UNITED STATES PATENT AND TRADEMARK OFFICE

Office Action Summary	Application No.	Applicant(s)
	10/595,331	WAKAYAMA, TAKAHIRO
Examiner	Art Unit	
John P. Zimmermann	2861

DETAILED ACTION

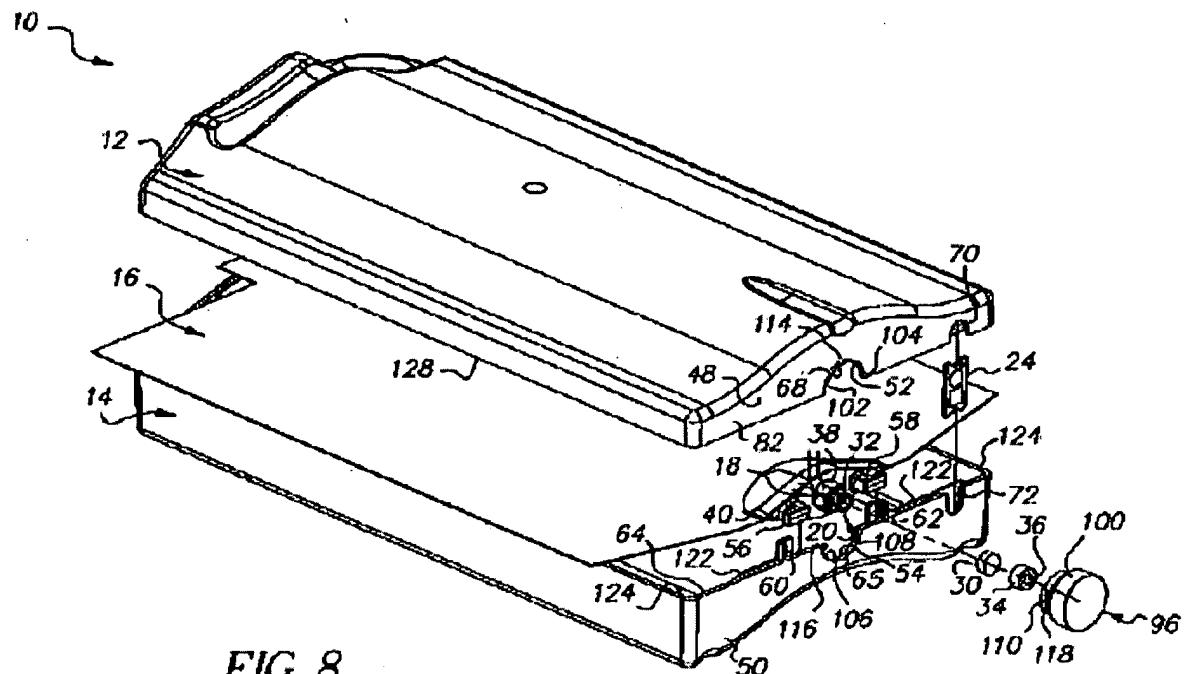
a. As related to independent **claim 1**, Perkins et al. teach an ink container which is mounted on a printing device [i.e. ink cartridge for an ink jet printer], the ink container comprises a bag-like ink container body formed from a flexible sheet (Perkins et al. – Detailed Description, Column 3, Lines 19-49 and Figure 8, Reference #10 & #16, shown below), and an ink supply opening (Perkins et al. – Figure 8, Reference #32, shown

below), one end thereof communicating with the inside of the ink container body and the other end being connected to the printing device.

FIG. 16

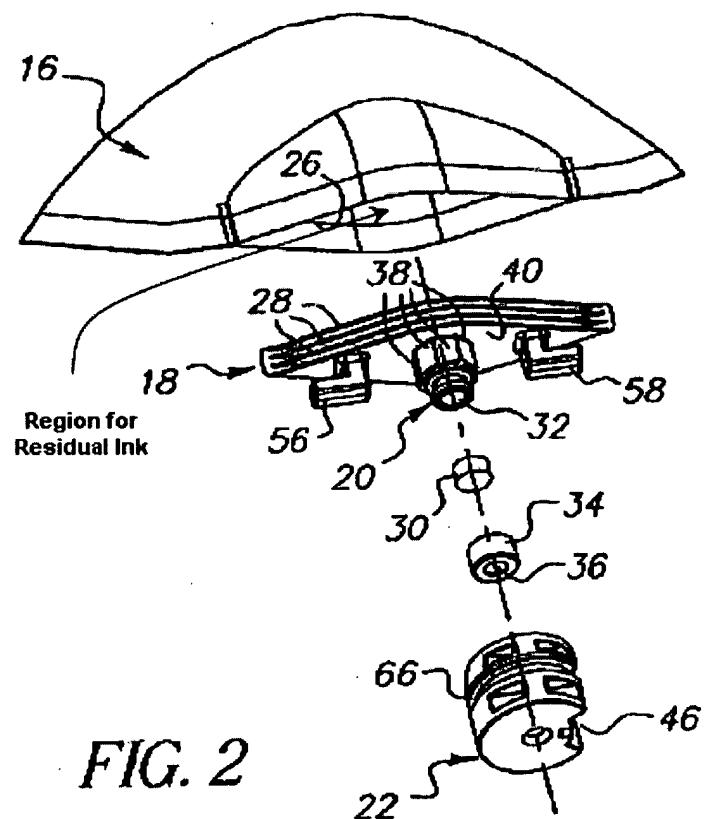
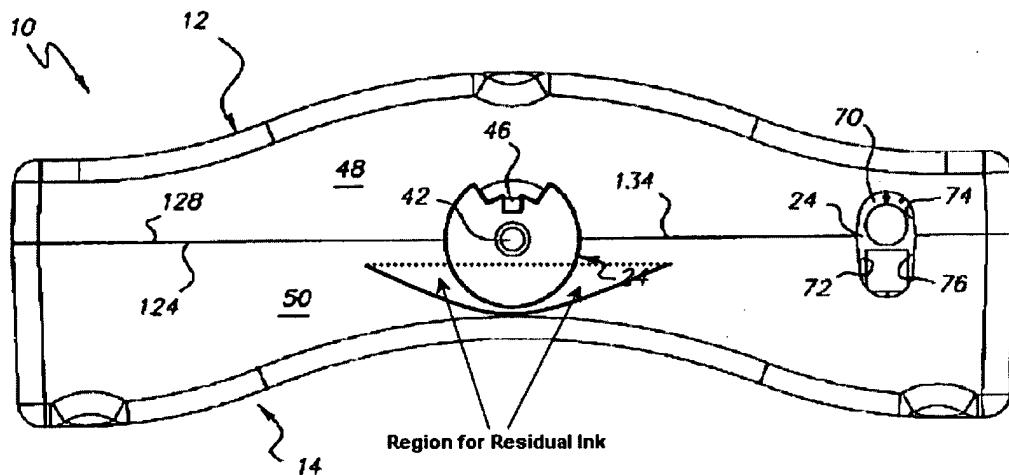
b. Continuing with **claim 1**, Perkins et al. teach the ink container body is provided with a region for residual ink liquid (Perkins et al. – Figures 2 & 16, Reference Arrows, both shown below), the region being disposed at the bottom, lower than the communicating end of the ink supply opening, and with shape retaining means for keeping the shape and volume of the region for residual ink liquid (Perkins et al. – Figures 2 & 16, Reference #18, #42, & Arrows, both shown below).

c. As related to dependent **claim 2**, Perkins et al. teach the region for residual ink liquid consists of a part of the bottom portion of the ink container body and is disposed below and on the border of the ink supply opening (Perkins et al. - Figures 2 & 16, Reference Arrows, both shown above) wherein the bottom portion of the ink container body rests on the bottom portion of the ink container [i.e. bottom housing half] (Perkins et al. - Figures 8 & 16, Reference #14, both shown above).

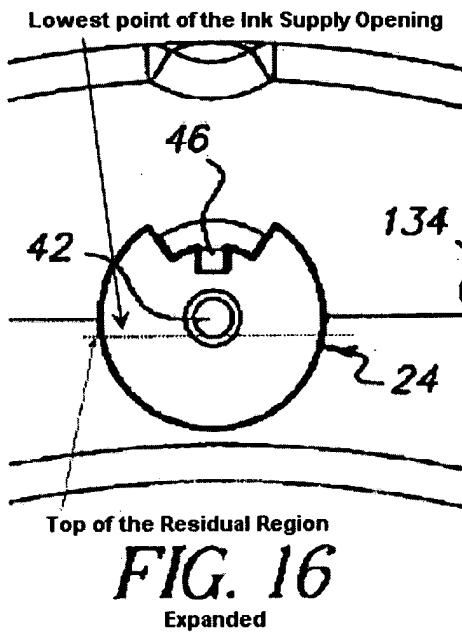
d. As related to dependent **claim 3**, Perkins et al. teach the region for residual ink liquid is disposed in such a manner that a top surface thereof coincides with the lowest point of the communicating end of the ink supply opening (Perkins et al. – Expanded Figure 16, Reference Arrows, shown below).

FIG. 7

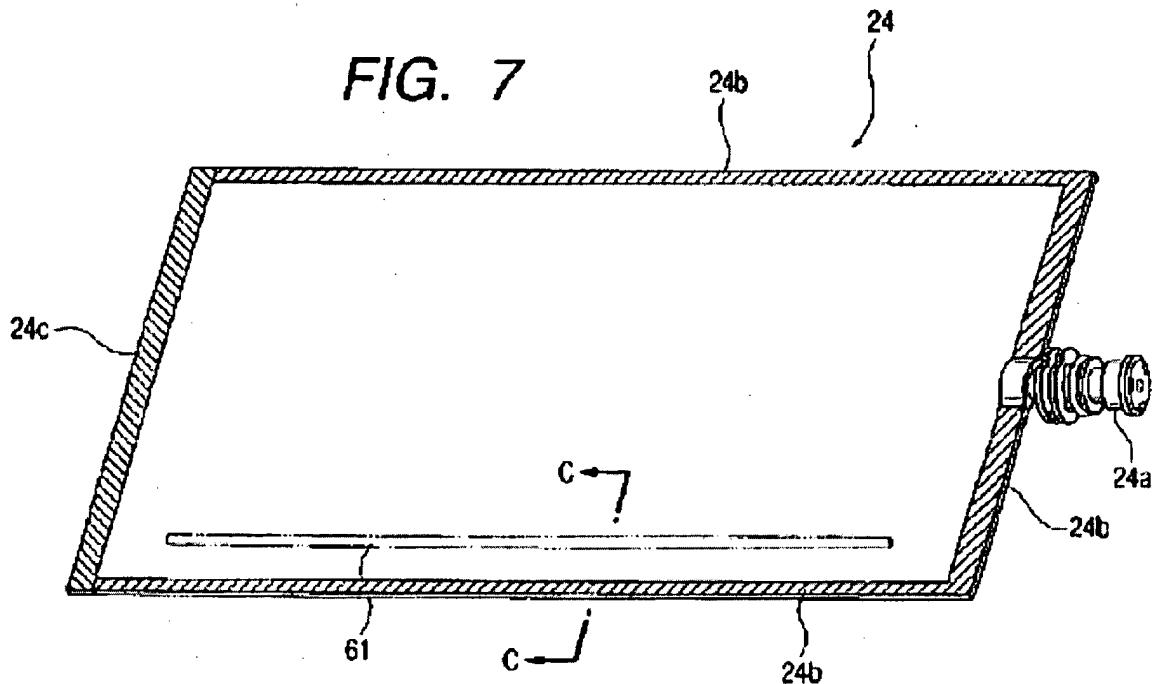
a. As related to dependent **claim 6**, Perkins et al. teach the shape retaining means can prevent the sheet from entering the area, but *do not* specifically teach the member having an orifice pore which allows ink to pass through. **However**, Ishizawa et al. teaches a specific shape retaining means [i.e. contact prevention member] housed in an ink pack of similar structure, form and function to that of Perkins et al (Ishizawa et al. – Abstract and Figure 7, Reference #61, shown below).

FIG. 29

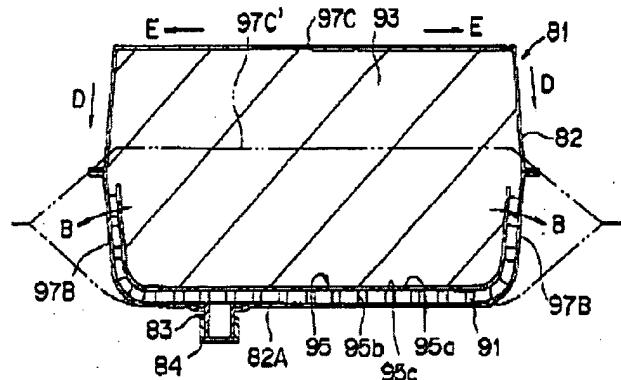
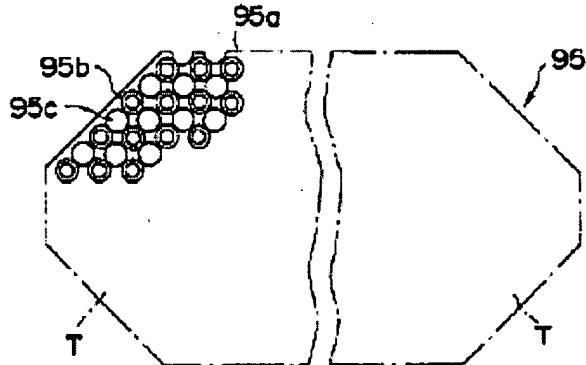
b. Continuing with **claim 6**, Sasaki et al. clearly teaches a shape retaining means that is a sheet-entry preventing member having an orifice pore [i.e. liquid opening] or a plurality of orifice pores on the top surface thereof, the pore being allowable of coarse-grained ink through-passing (Sasaki et al. – Detailed Description, Column 11, Lines 30-66 and Figures 27-28, Reference #95, #95a, #95b & #95c, all shown below).
